ICHD - ENVIRONMENTAL HEALTH DIVISION

PERMIT # AP 317438

SEPTIC: IMPROVEMENT PERMIT / AUTHORIZATION TO CONSTRUCT / OPERATION PERMIT / EXISTING SYSTEM

SITE ADDRESS: 165 Olympia Dr Mooresville NC 28117 | PHONE: 561-459-0689 | ALT. PHONE

AS BUILT SKETCH

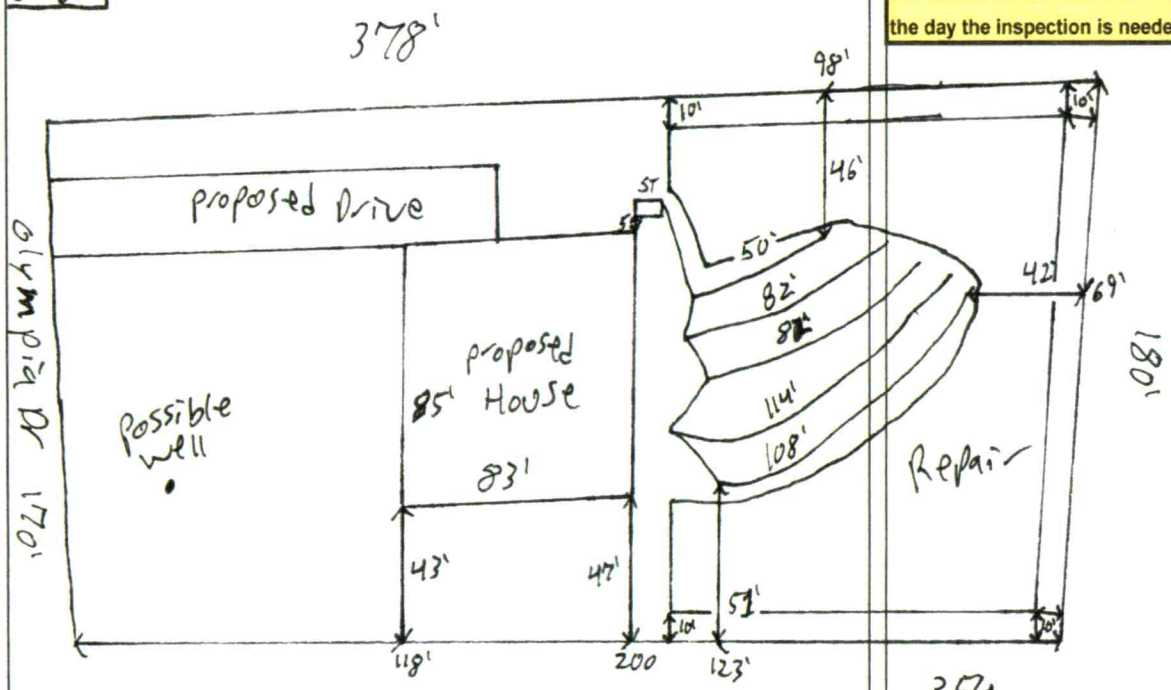
2-21-23 * See attached as built/GIS MAP
- Part of Drainfield Area Dugout + Removed.
- System Repair Changed to Drip Repair Due to Large amount of Rock on site

- pits Dug on site to Relocate Drainfield - LTAR evaluation = .30 only 400 ft Required 24 in Depth (See Soil notes on back).

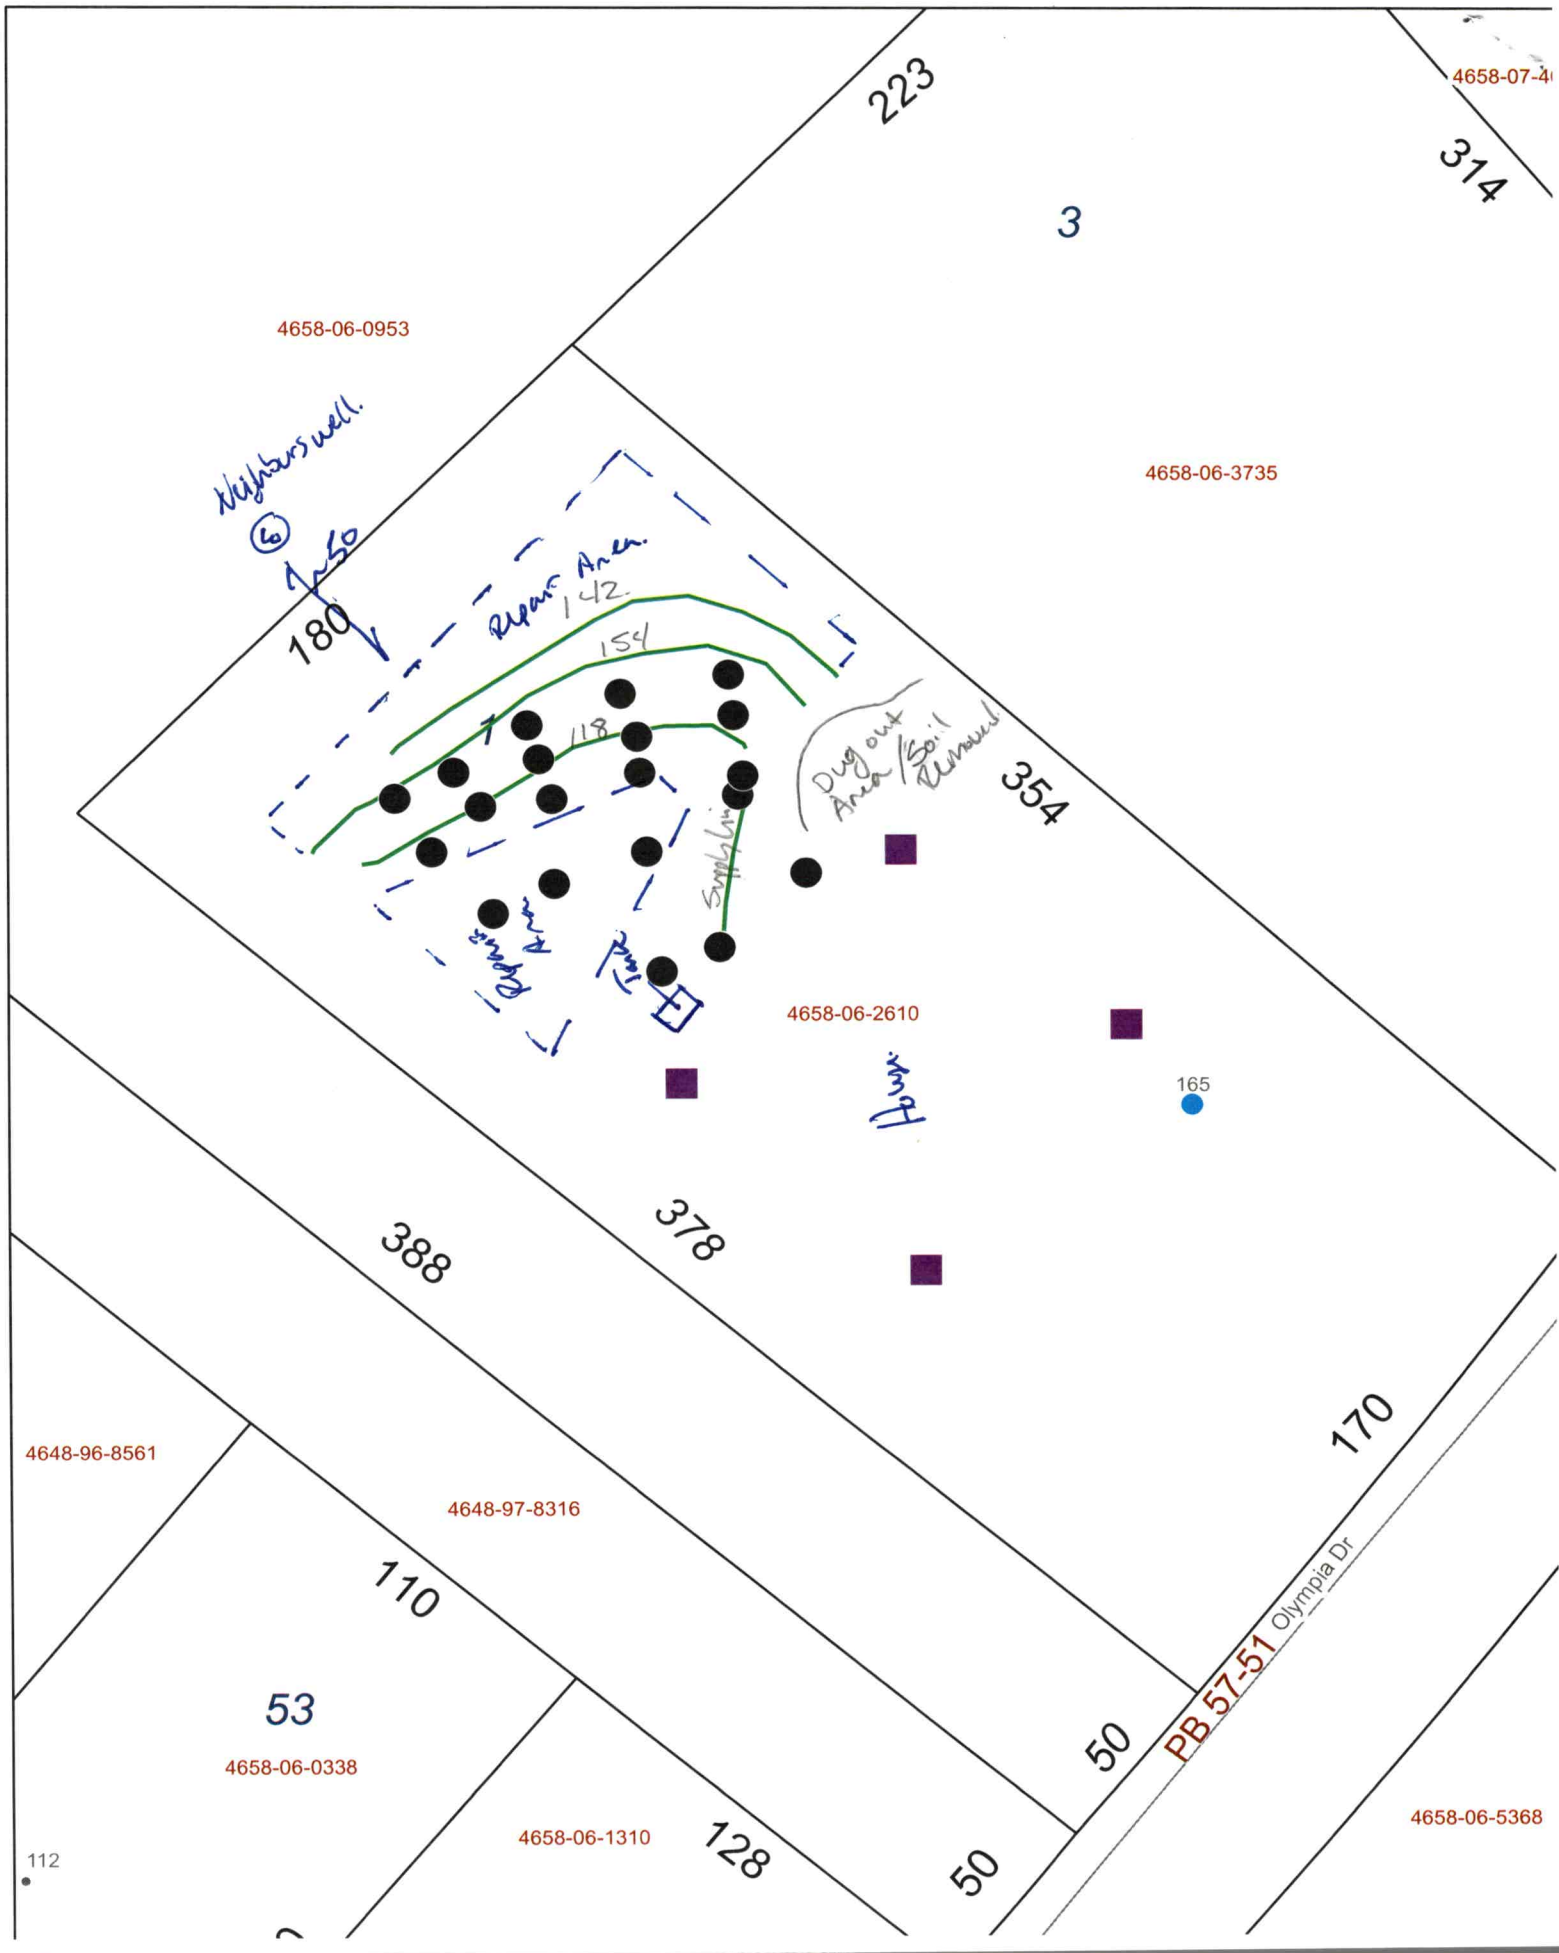
Rock Encountered throughout Drainfield.

3 pits Dug

1) 0-10 C
10-36 CL
36-46 - LSAP.
46+ - Rock.
PS. 325.

2). 0-15 C
15+ Rock content

3). 0-8 C
8-36 CL
36-55 C SAP
PS .325

4) ~~Rock~~
0-10 C
10-24 Rock

5) Rock
